Complaints And Suggestions from Gulmohar Residency

Quality Control Check Report. Stage: After Plumbing & Electrical (Apartments)

GULMOHAR RESIDENCY

Details of Additions & Alterations

F-601
[Plumbing]

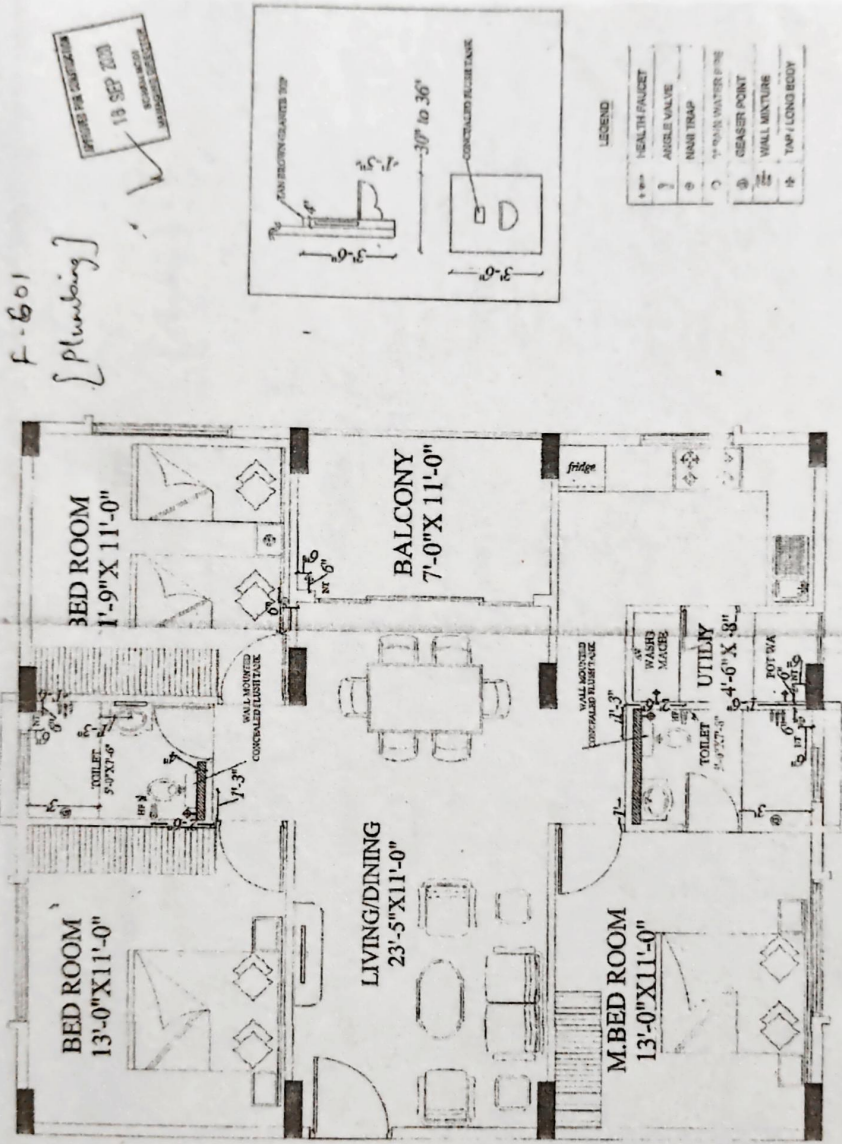
Remarks NOTE :- 1) level marking was not provided.

2) In bathrooms, shower height to be provided at [6'3"] instead of [6'6"]

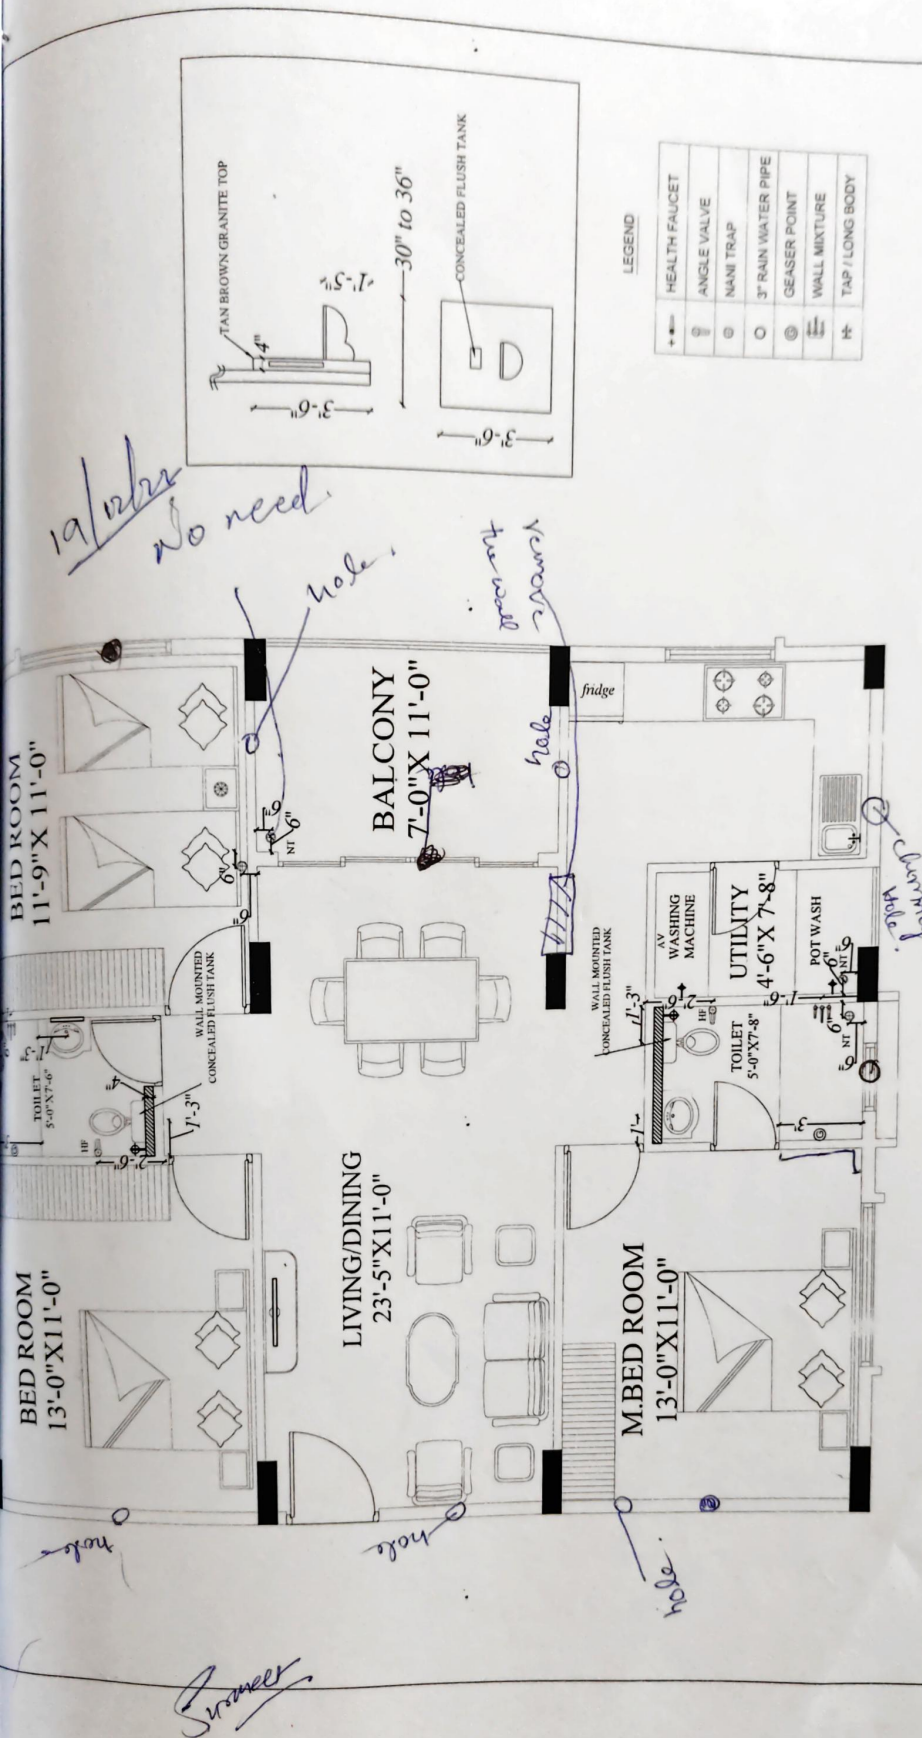
Choice of Bathroom tiles, CP fittings & Sanitary ware:

Indo western commod.

Bathroom exhaust fan needed.

Bathrooms proper slope for draining
water.

M. T. - Jaipur Panna (wall and flooring
single tile)

C. T. - Jaipur Panna (wall and floor-
-ing single tile)

utility - Jaipur Panna.

19/12/24 Kitchen - Balcony - Jaipur Panna
~~No need of plumbing in balcony.~~
